PRELIMINARY DRAINAGE REPORT
for
WINDERMERE FILING NO. 2

Colorado Springs, CO

April 6, 2022

DRAINAGE PLANS FOR
WINDERMERE FILING 2
 N. MARKSHEFFEL ROAD
 EL PASO COUNTY, COLORADO

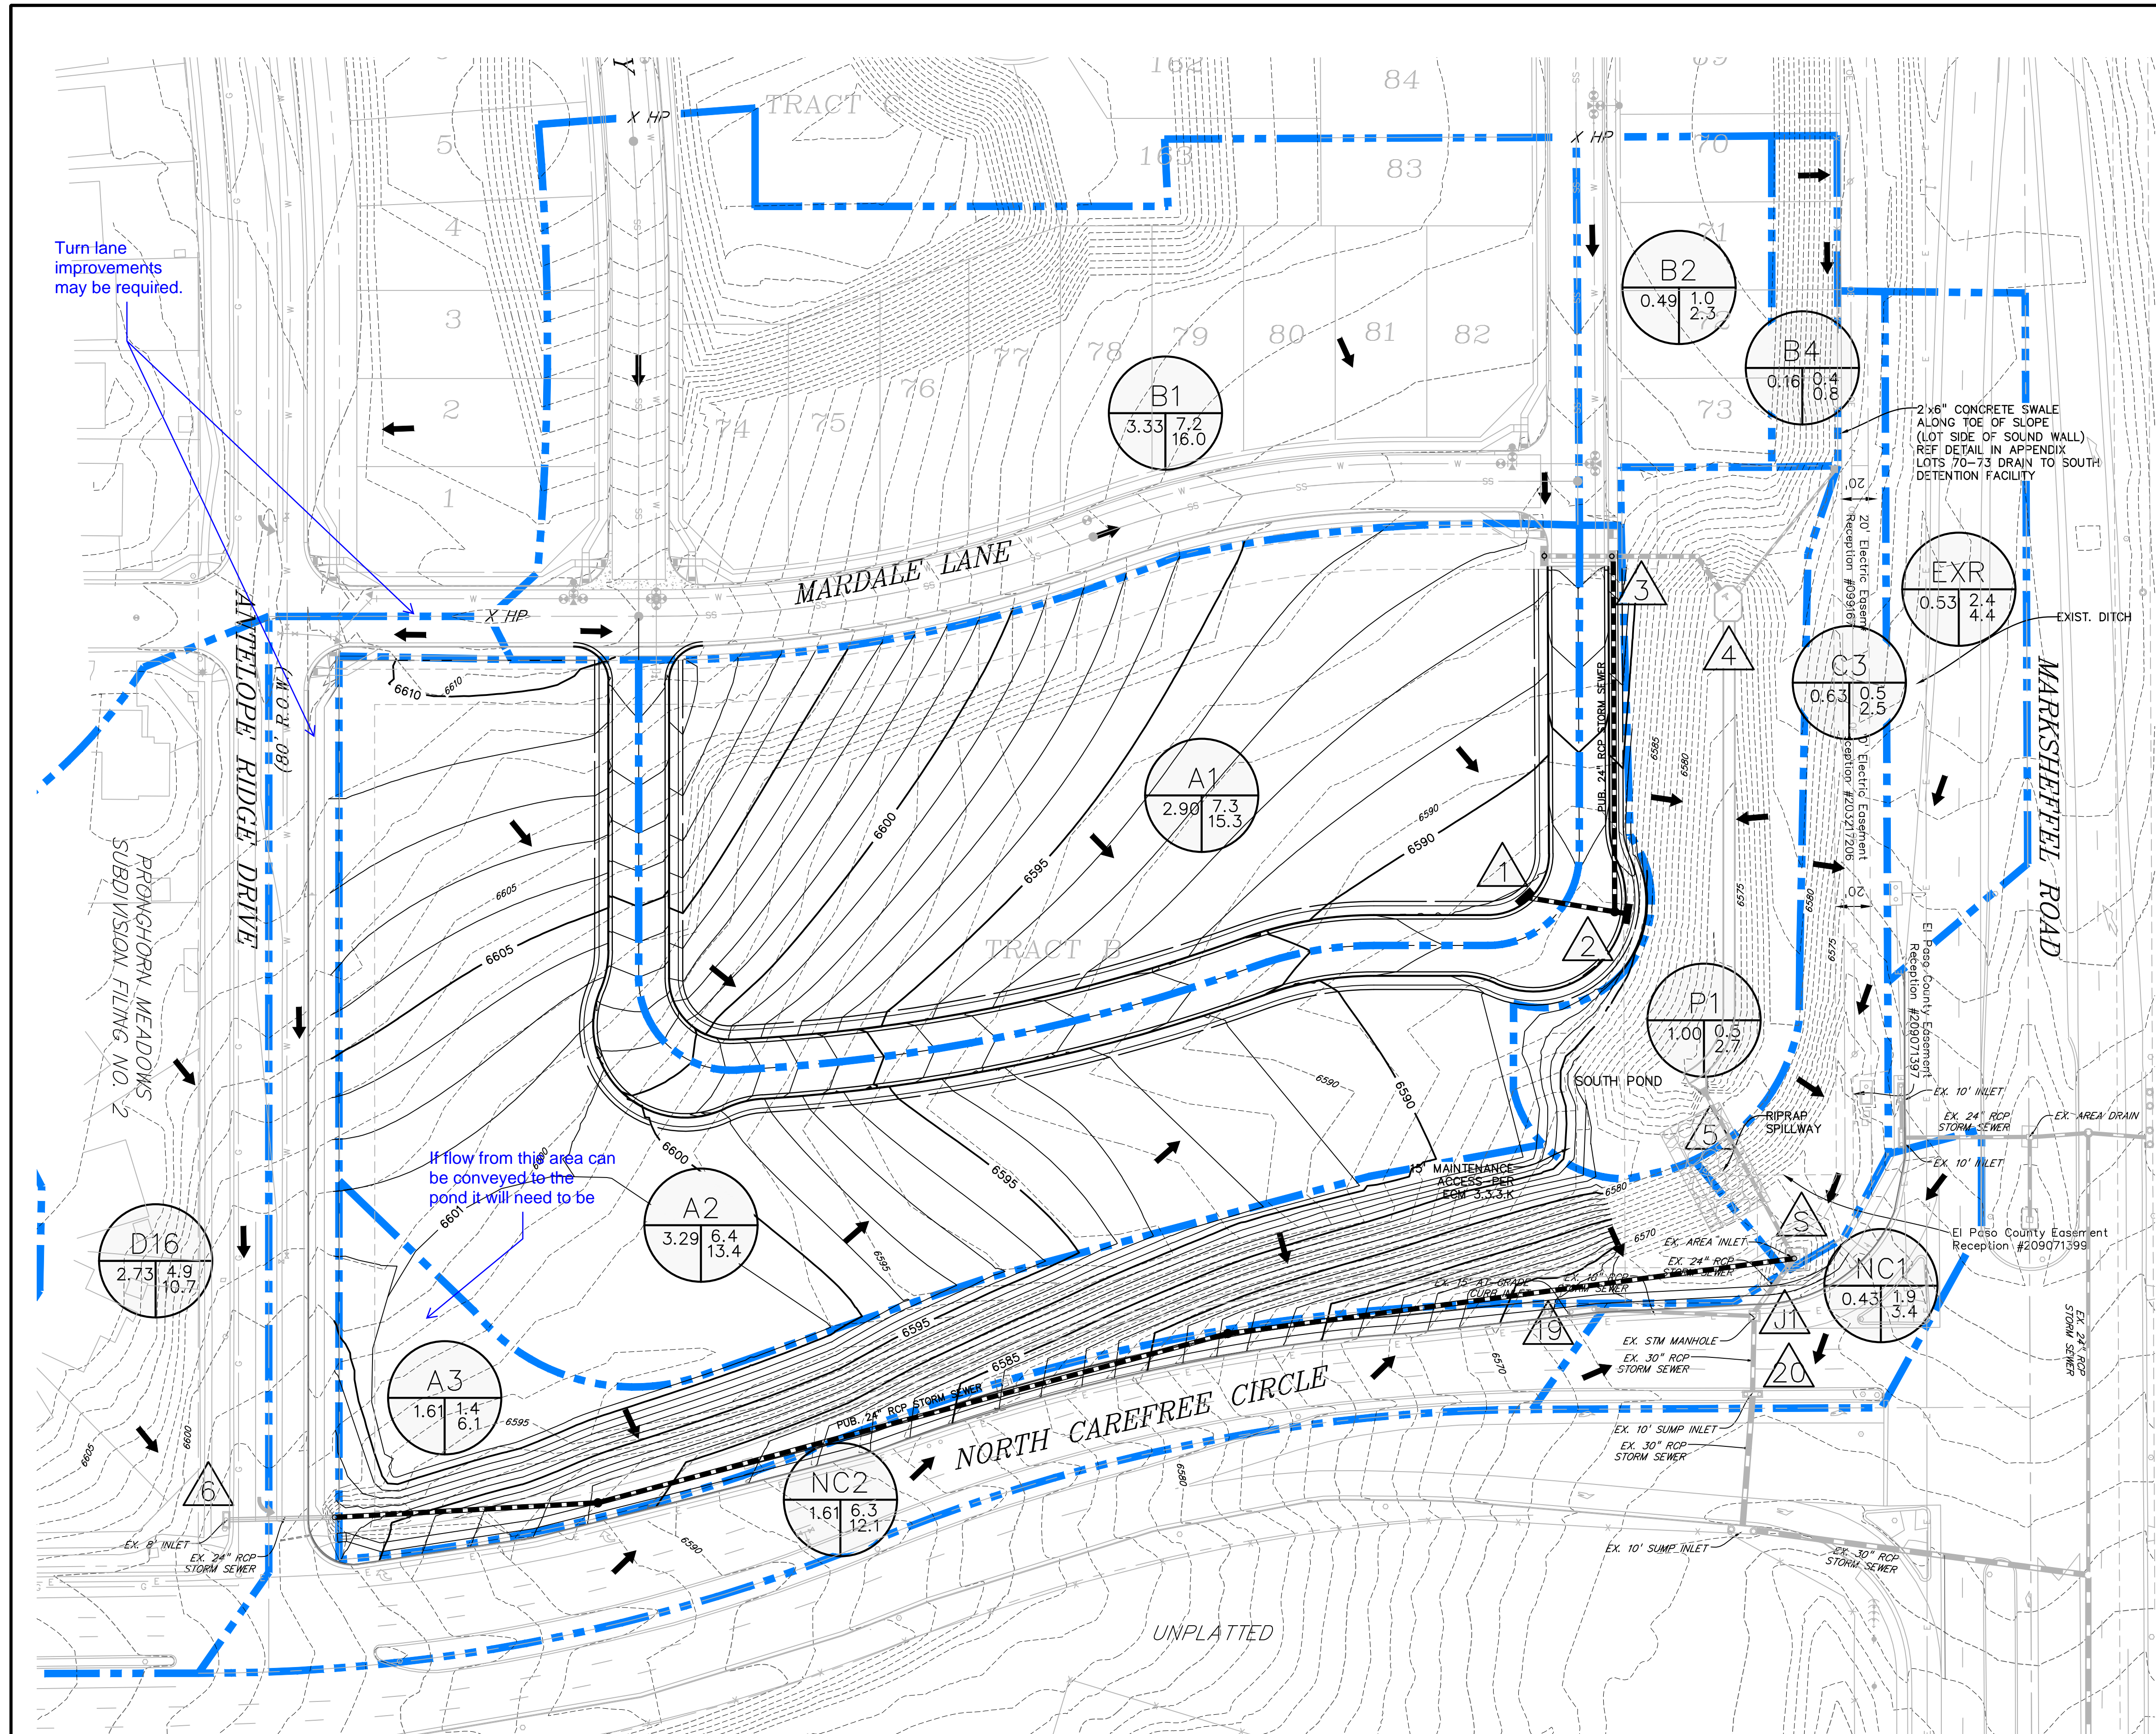
Does this drain onto the property? If so, would it go to DP S, not into the pond?
